LA-UR-04-6777
September 2004

Response to Concerns About Selected Regional Aquifer Wells at Los Alamos National Laboratory

Prepared by
Risk Reduction and Environmental Stewardship Division–Groundwater Protection Program

Figure 1. **Schlumberger Formation Microimage (FMI) of two 20-ft depth intervals within Puye Formation fanglomerates at well CdV-R-15-3**

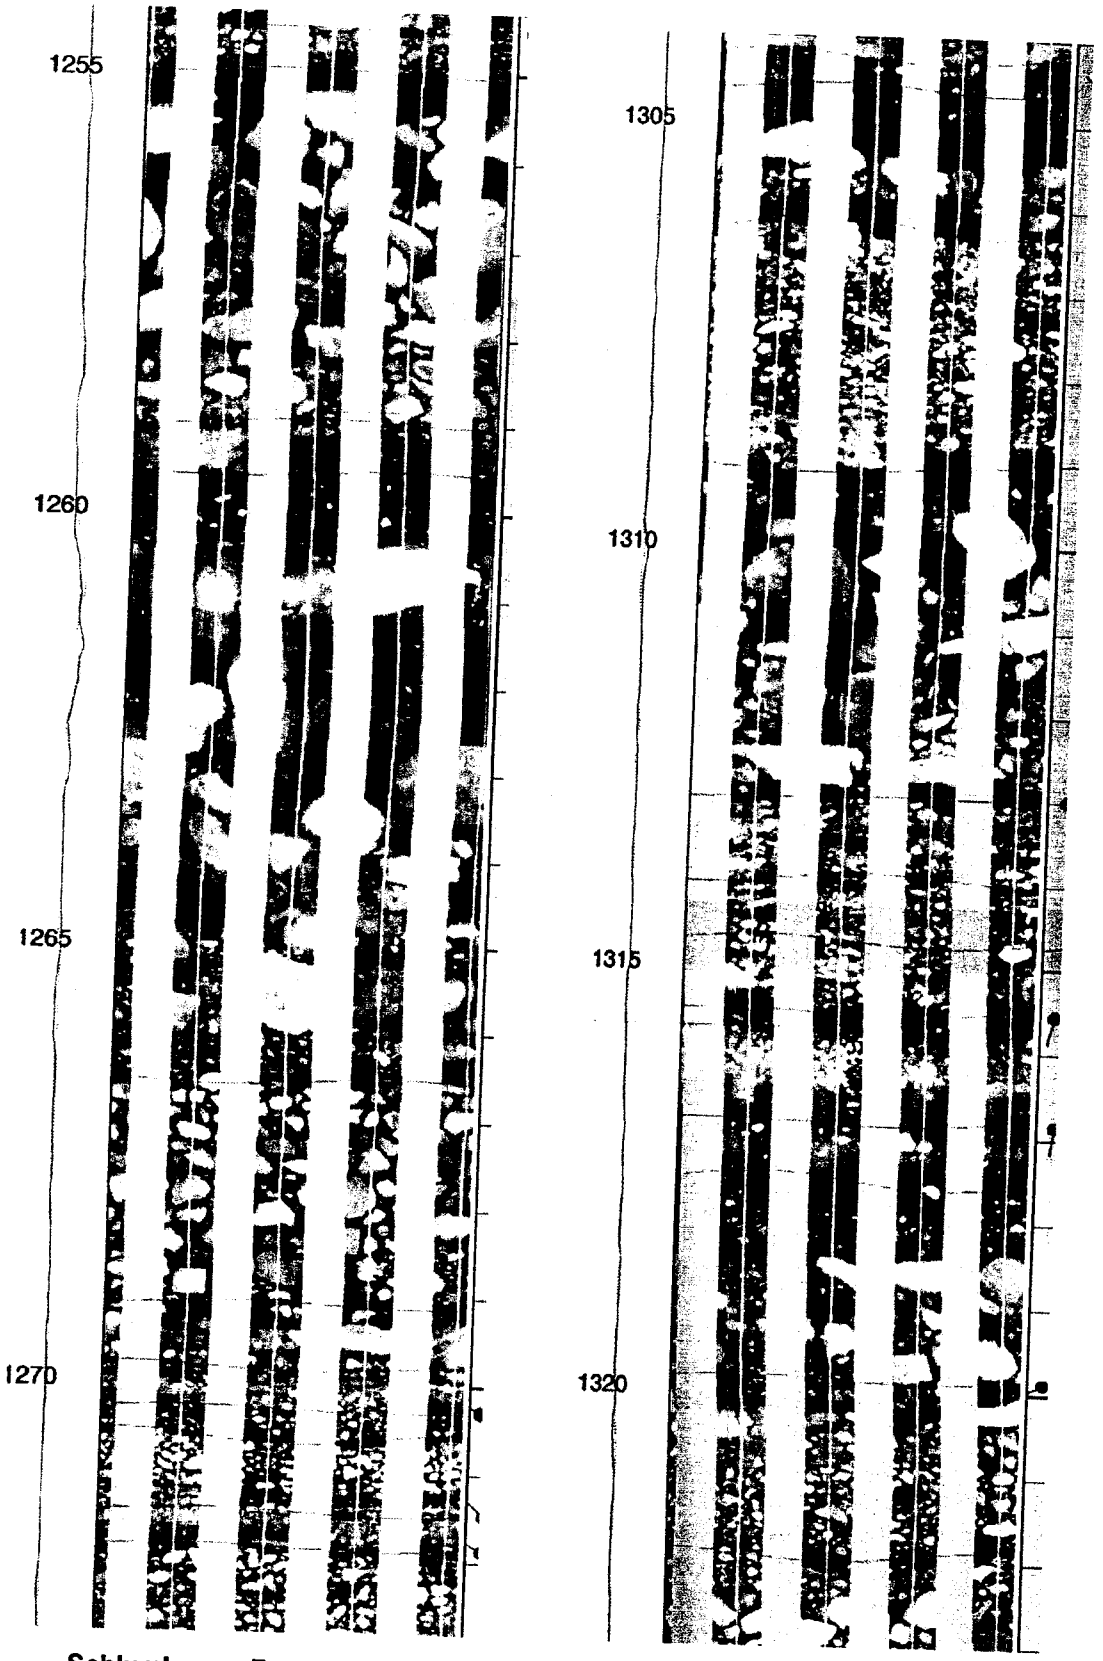
Within screened intervals there is fine-scale stratigraphic variability in most aquifer units, which Gilkeson (2004) defined as "multiple hydrogeologic units". For example, Figure 1 shows a Schlumberger Formation Microimager (FMI) log of sedimentary clast sizes, shapes, and layering within the Puye Formation at drill hole CdV-R-15-3. The strip on the left (depth: 1254–1274 ft) shows the aquifer material within the 43.8 ft screen that straddles the 1245-ft deep water table. The strip on the right shows a deeper zone of even finer-scale stratigraphic variation, including multiple thin beds of fine silt or clay (dark bands). These images show that heterogeneity is an intrinsic characteristic of the Puye Formation on scales as small as 1 ft or less and that few beds of homogeneous lithology are more than 3 ft thick. Because there are no *a priori* methods for selecting which of these many depositional layers represent preferred contaminant pathways, geophysical logs are used to identify representative sections of high permeability.
